MIDLAND NUCLEAR PLANT -
UNIT NO 1, DOCKET NO 50-329
UNIT NO 2, DOCKET NO 50-330
SETTLEMENT OF DIESEL GENERATOR FOUNDATIONS AND BUILDING

MIDLAND RESPONSE TO 10 CFR 50.54 REQUEST

ON PLANT FILL: MEB COMMENTS

APPLICANT: CONSUMER POWER COMPANY
FACILITY: MIDLAND PLANT, UNITS 1 & 2
SUBJECT: SUMMARY OF JANUARY 16, 1980 MEETING ON SUPPLEMENTAL REQUESTS
REGARDING PLANT FILL

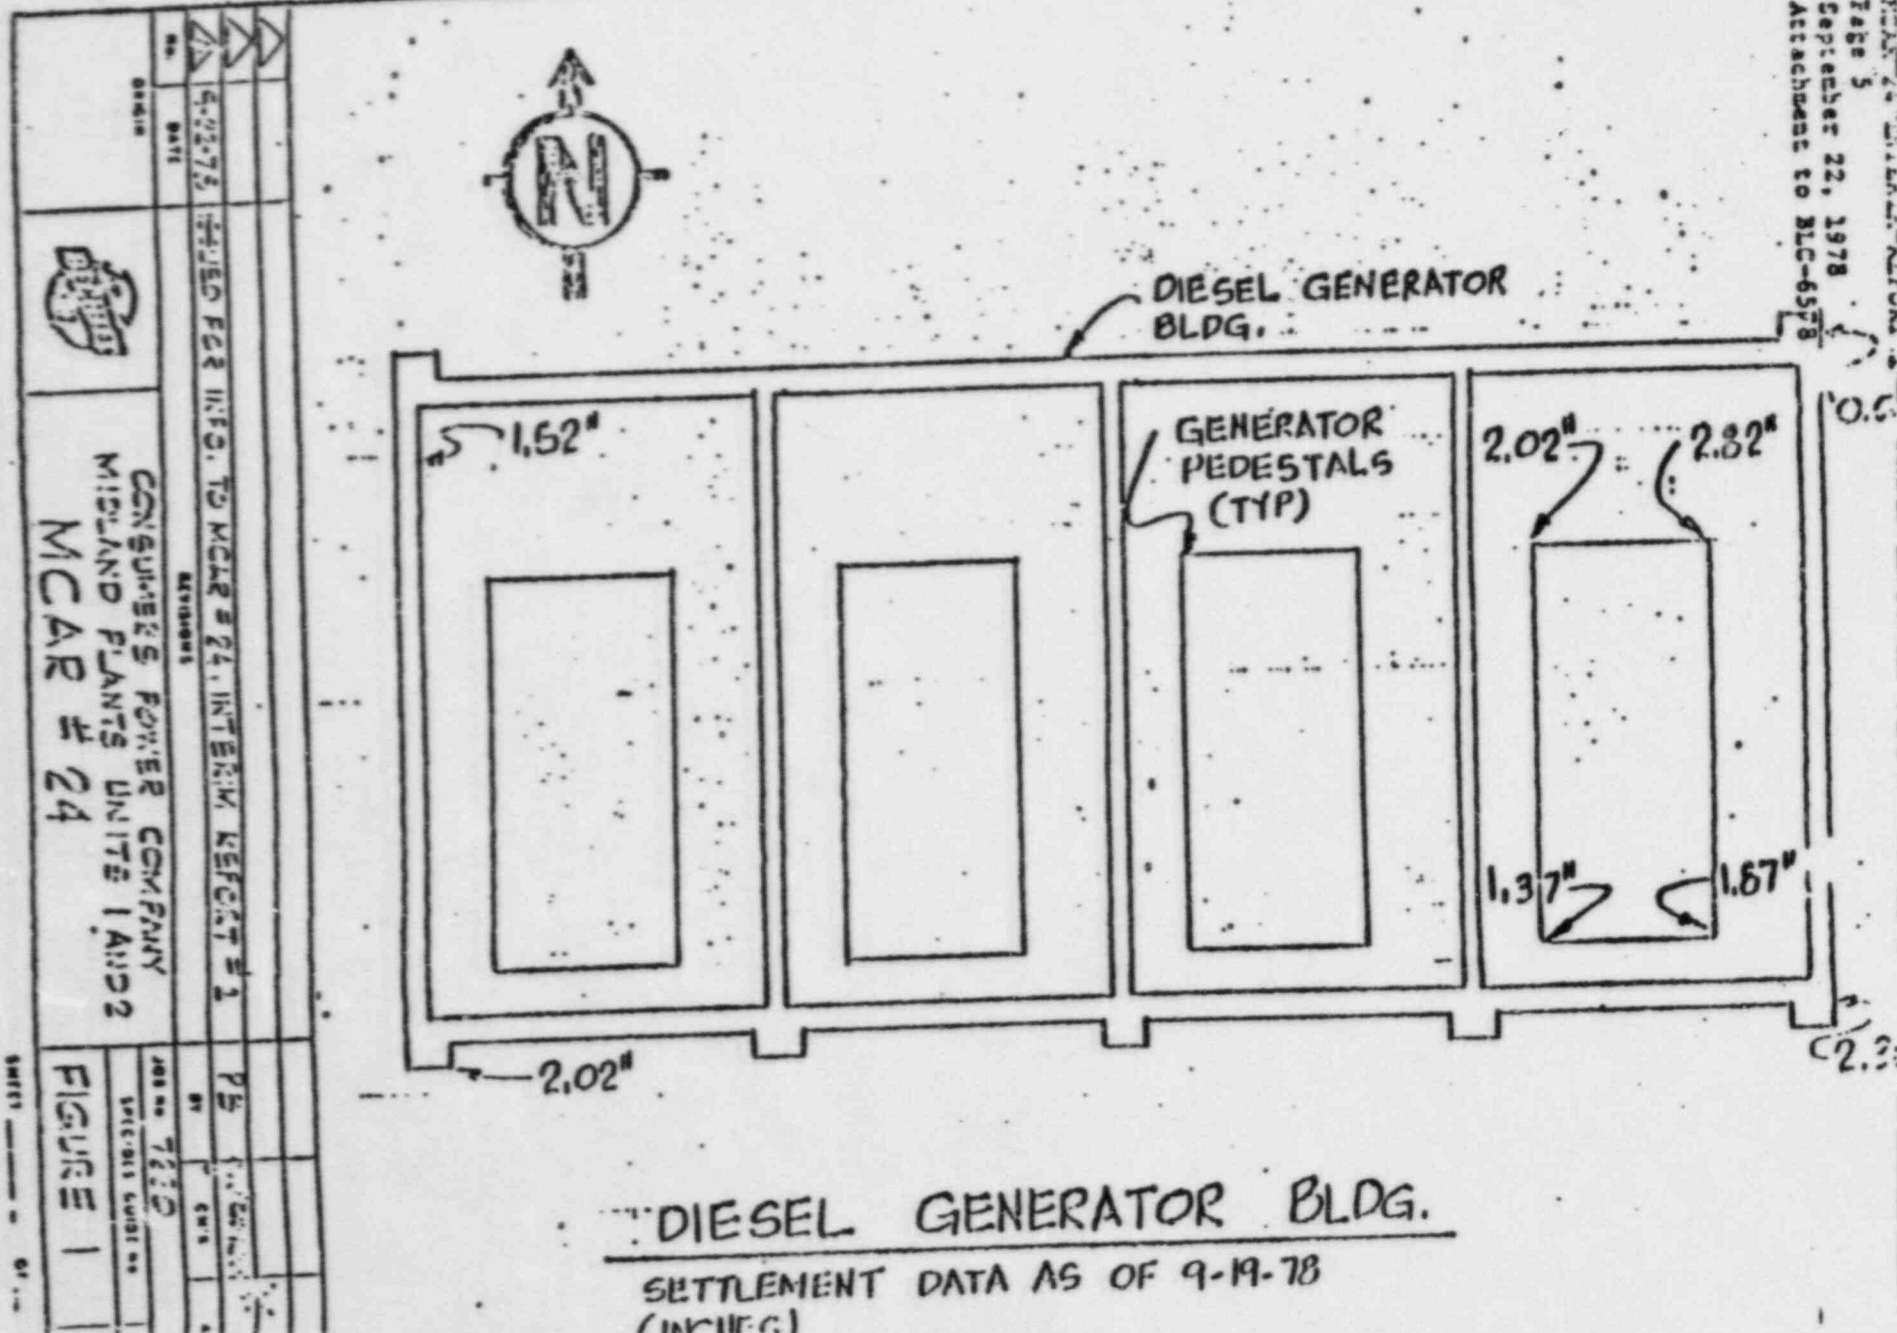
The general foundation and building settlements, as of September 19, 1978, are shown on Figure 1 (attached).

NOT TO BE
 REPRODUCED
 WITHOUT
 PERMISSION
 OF THE
 AUTHORITY
 FIGURE 19-1

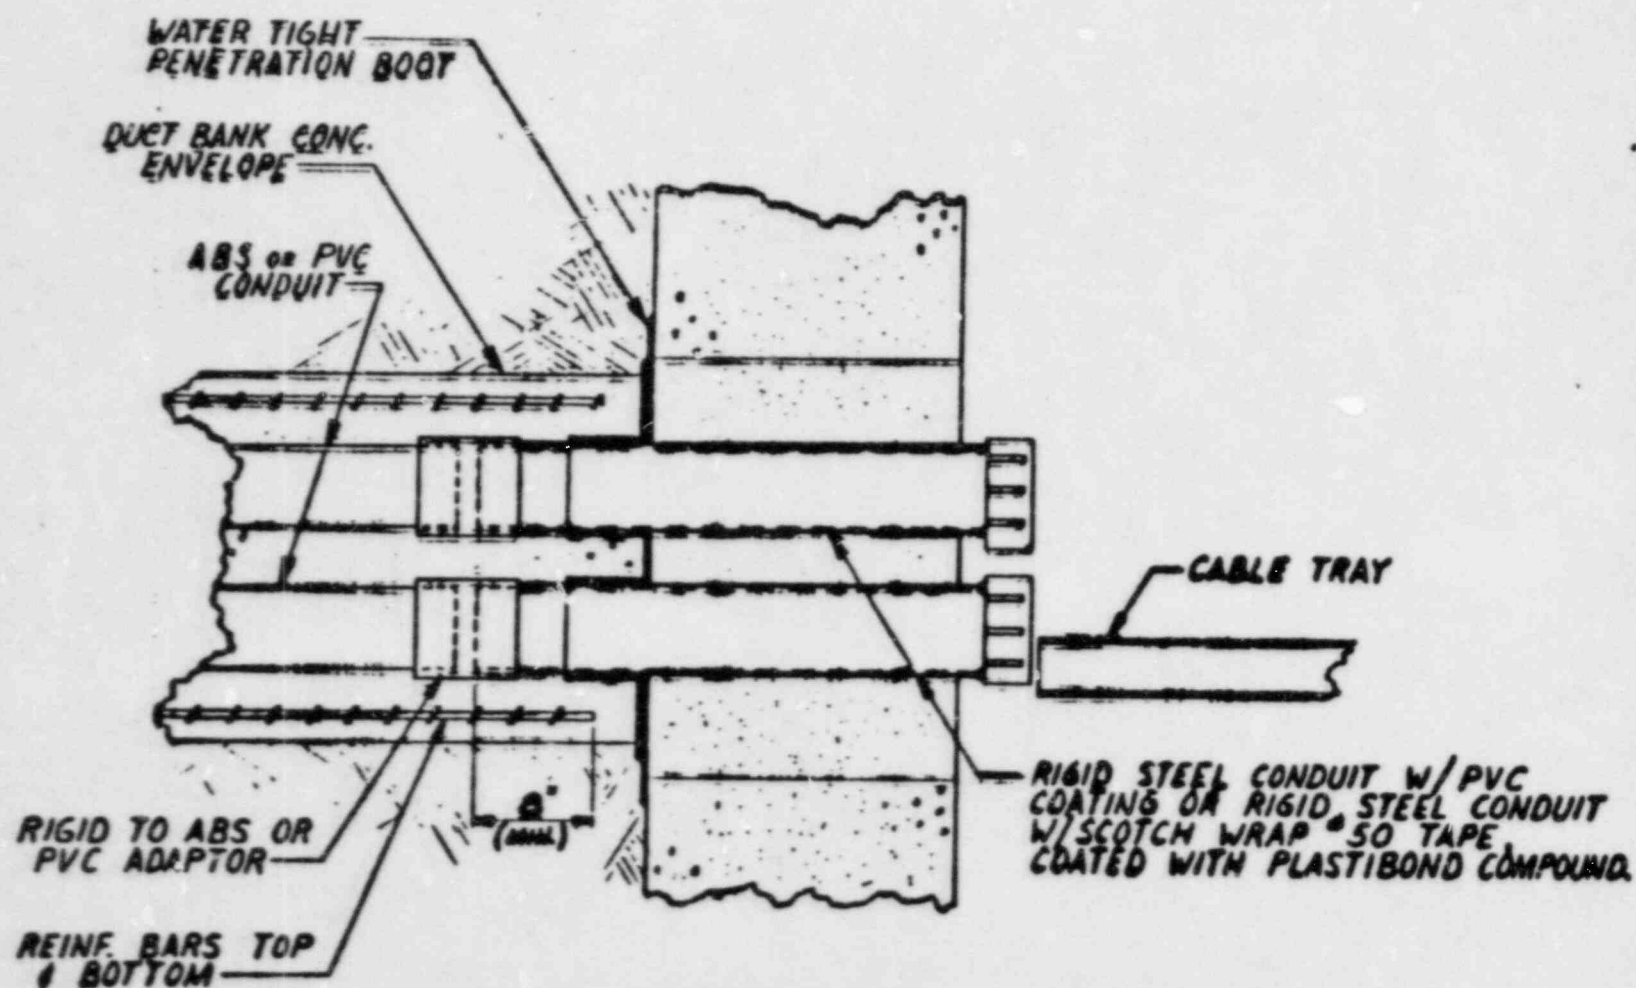
9. RESPONSE TO QUESTION 19, PAGES 19-1 TO 19-3

The disposition of this response will be delayed pending receipt and review of evaluations based on the preload program (See last paragraph on Page 19-3).
